# Planning Commission

June 27<sup>th</sup>, 2018

AGENDA

APPLICATION FOR SITE PLAN APPROVAL  
FOR CEDAR POINT SPORTS CENTER  
INDOOR FACILITY AT 2700 CLEVELAND  
ROAD

**OVERALL SITE PLAN**

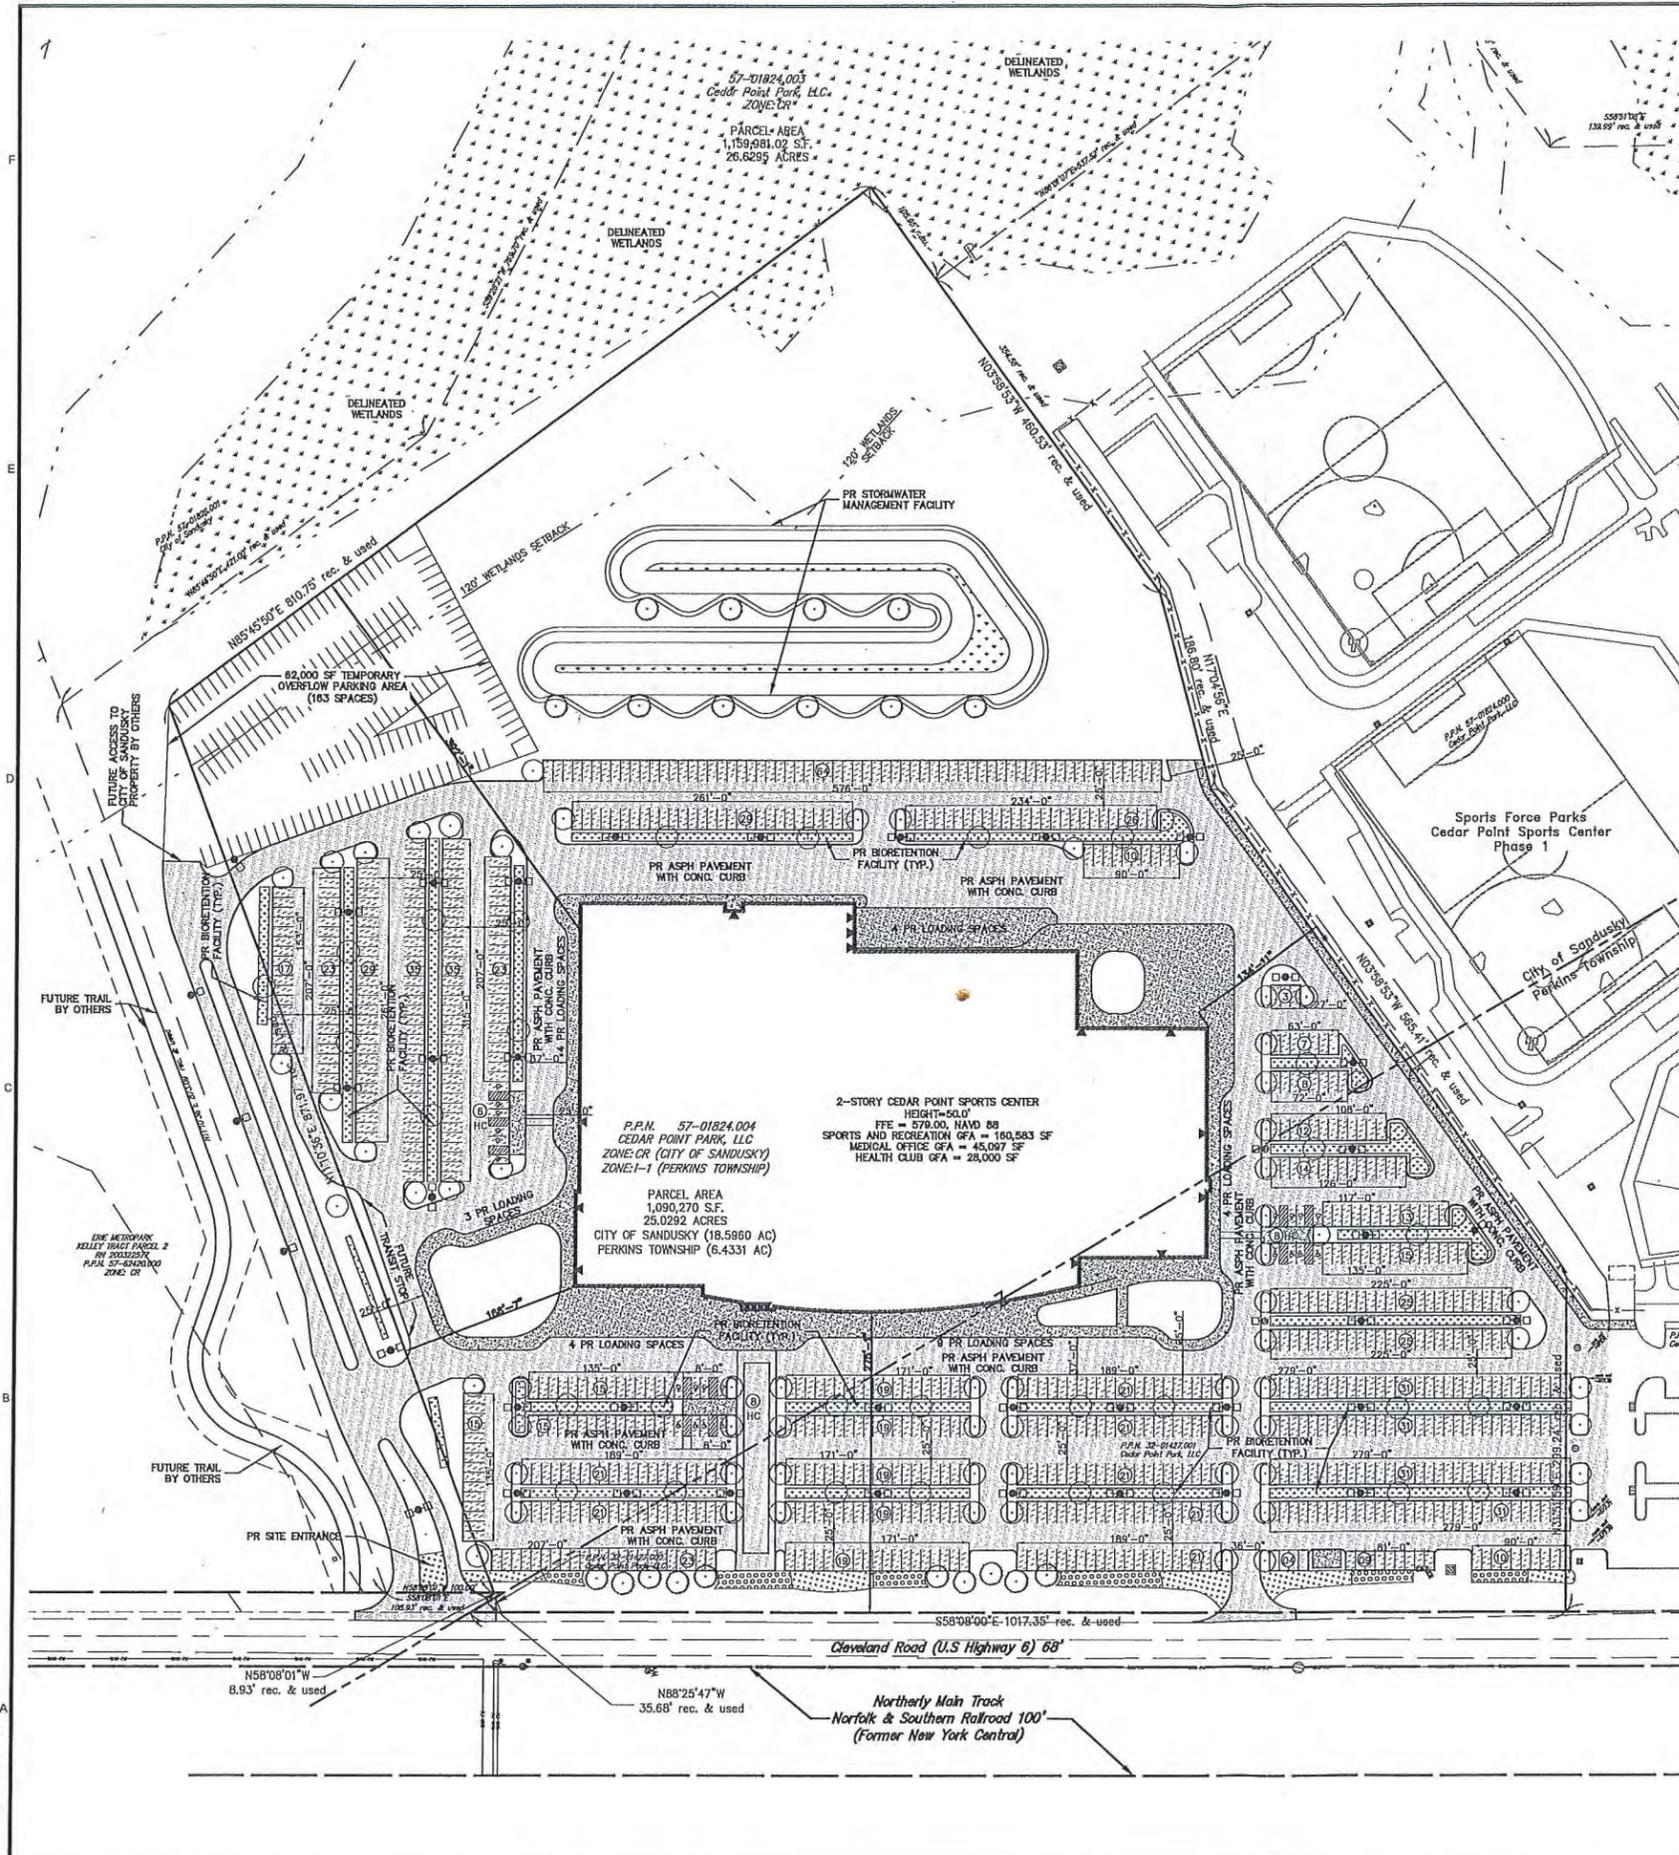
Staff's main concern regarding the proposed site plan is in regard to the amount of parking being proposed. The square footage and parking requirements per use is as stated below:

As noted above the proposed uses would require 646 parking spaces and the applicant is proposing 871 spaces and 22 handicap spaces. However, it is important to note that the code does not directly speak to indoor sports facility. The proposed site plan exceeds the City of Sandusky's required parking for the proposed uses. It is important to note that the Phase 1 project, which provided 458 spaces and required number of handicap spaces, has experienced many overflow parking issues since it began operation in 2017. The parking for the Phase 2 may supplement those parking shortfalls at times, but staff does believe that there will be times when overflow parking will still be necessary.

1. Sports Force Phase 1 has large RV's parking in the overflow area yet the Phase 2 drawings do not show a dedicated parking location for these or busses.
  2. The Parking is based on all volleyball courts being used at one time, however there is concern for parking overlap as attendees will be arriving early or staying later.
  3. The site plan shows 150' wetland setback. Per Osborne the setback is 75' from wetland.
  4. The East access drive is identified as right in-right out in the traffic study.
  5. It is believed that the drive entrance may be too narrow.
  6. Circulation of transit and busses of a concern.
  7. Storm water management design is of a slight concern but discussion regarding this and other items will be occurring on 6/26/2018.
-

1. ODOT approves the traffic study and all ODOT conditions are met.
2. Although the applicant has indicated that temporary overflow parking will be constructed on the northwest corner of the site and on the parcel east of the outdoor facility, staff strongly recommends that the applicant also look to provide permanent pocket parking around the existing fields in Phase 1.
3. The site plan shall be revised, for staff approval, to show a designated trailer parking area. This area shall not be permitted within the permanent parking areas. They could be permitted in overflow parking areas or off-site.
4. Eastern drive shall be signed right in and right out only.
5. The site plan shall be revised, for staff approval, to show the traffic flow for transit.
